— Technical Requirements

CB USE ONLY	Application number RA21043	Legal land description NE 15-42-24 W4M
<input checked="" type="checkbox"/> Approval <input type="checkbox"/> Registration <input type="checkbox"/> Authorization <input type="checkbox"/> Amendment

Double T Cattle Feedlot

PROPOSED CATCH BASIN
G/W LINER IN ACCORDANCE WITH
GEO-TECHNICAL RECOMMENDATIONS
FREESBOARD ELEVATION=864.500m
POND TOP/HWL ELEV=864.000
1.30YR RAINFALL ELEV=863.500
POND BOTTOM=862.500
HWL VOLUME=9,650m³
1.30YR VOLUME=6,070m³

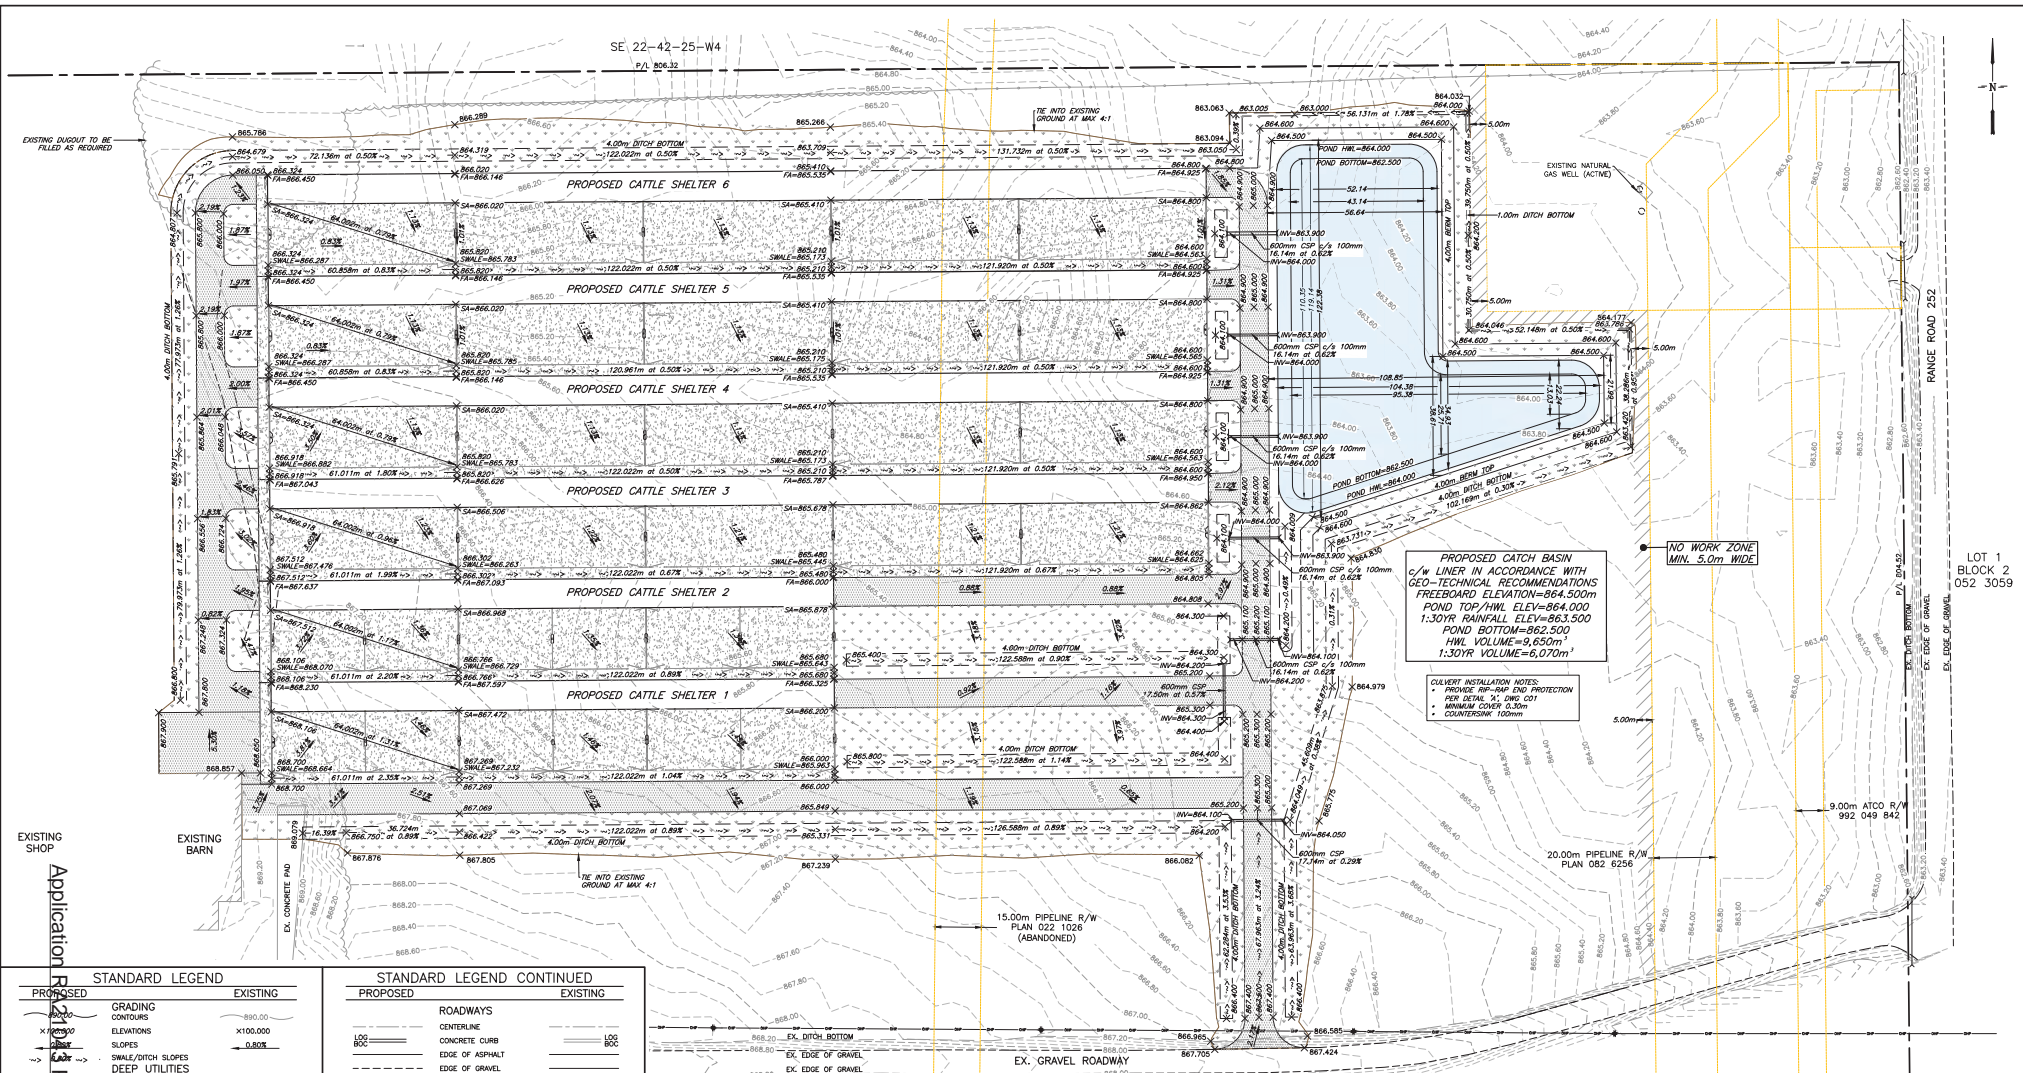
* the southwest corner will be approximately 2.1 m below ground, the water table was observed to be as shallow as 2.47 m below ground surface in fall 2021. A condition will be added to the permit, see discussion in Decision Summary RA21043.

Catch basin
 Liquid manure storage volume calculator attached: YES NO
 Depth to water table: 2.47 m
 Depth to uppermost groundwater resource: 15.2 m
 Requirements met: YES NO
 Requirements met: YES NO
 As noted previously, a condition will be added to the permit to address water table separation.

Figure 1. Irregular shape catch basin. Al-Terra Engineering (Red Deer) Ltd., Site Grading Plan Sheet C02. #5, 2022-02-23. Color shading and labels added.

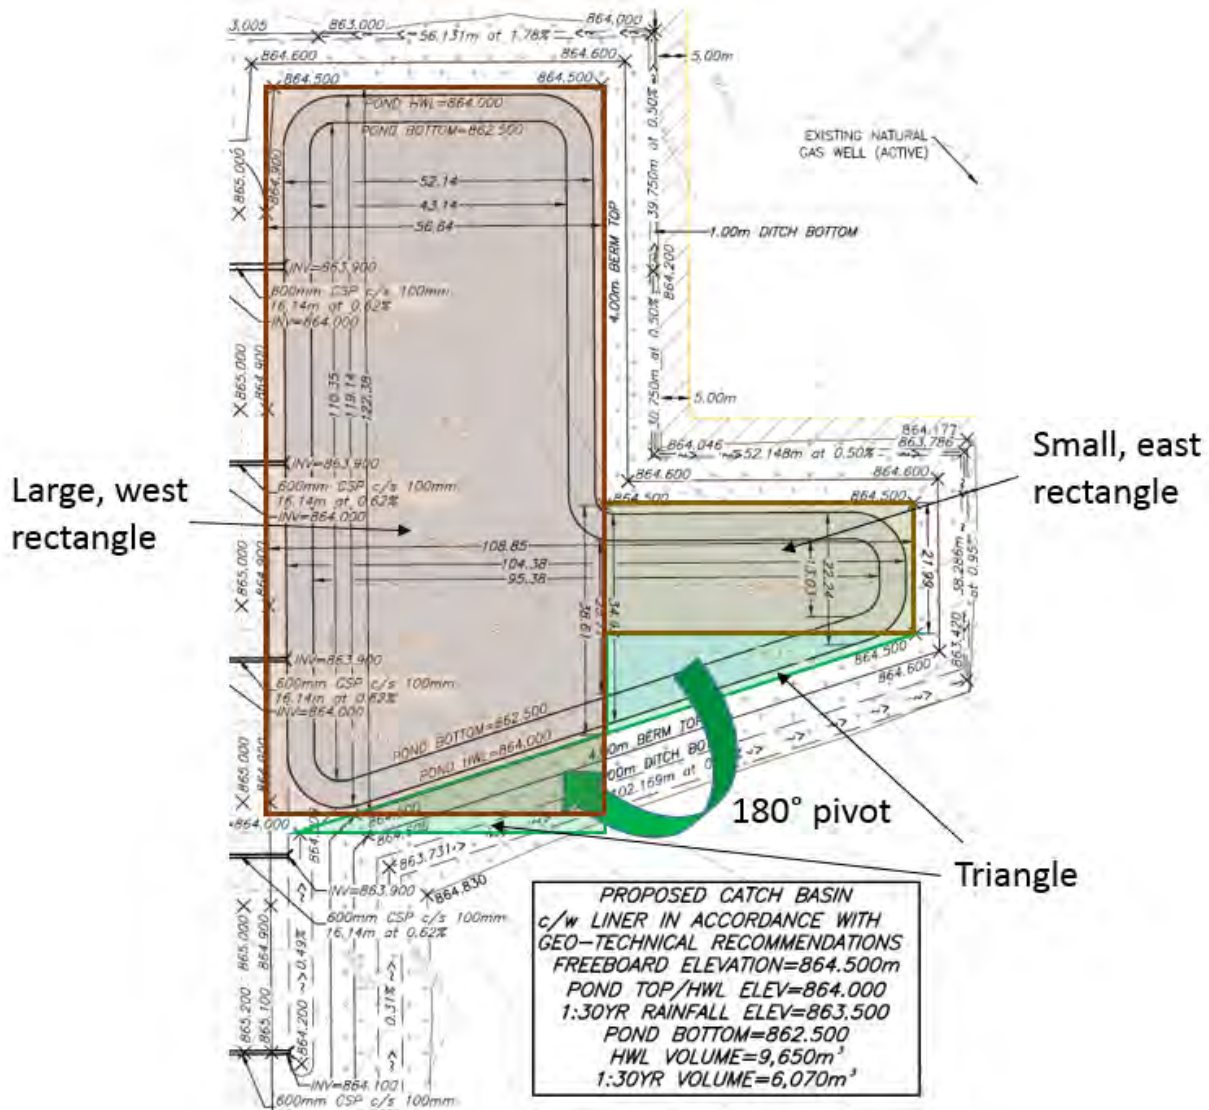
As shown in Figure 1, the Al-Terra engineering report lists a HWL volume of 9650m³ at a liquid elevation of 864.0m.

The chosen methodology to determine the storage volume is to “split” the irregular shape into two rectangular shapes, and calculate the volume for each shape (Figure 1):

- Rounded corners shown are calculated as “square”.
 - o This would result in a catch basin volume calculation being slightly larger than the actual catch basin volume.
- Angled catch basin slope on the southeast is split in approximately half, at the intersection of a line that would extend south from the interior berm east top of the large, west rectangle. The triangle on the east side of this slope (and south of the small, east rectangle) would pivot 180 degrees, and be added to the south east corner of the large, west rectangle. “Moving” this portion of the irregular shape catch basin would result in the dimensions of the two rectangles listed.

- As a portion of the triangle is shown beyond the dimensions of the large, west rectangle (Figure 1), this would result in a catch basin volume calculation being slightly smaller than the actual catch basin volume.
- Catch basin dimensions at west edge of entire catch basin are measured to gravel road (at 864.9m), rather than the catch basin top (at 864.5m) on the other sides.
 - This would result in a catch basin volume calculation slightly larger than the actual catch basin volume.
- Calculating the volume of two catch basins suggests that a “berm” (with 3:1 H to V side slopes) would be between them, when in fact the “berm” volume would be usable catch basin volume.
 - This would result in a catch basin volume calculation slightly smaller than the actual catch basin volume.
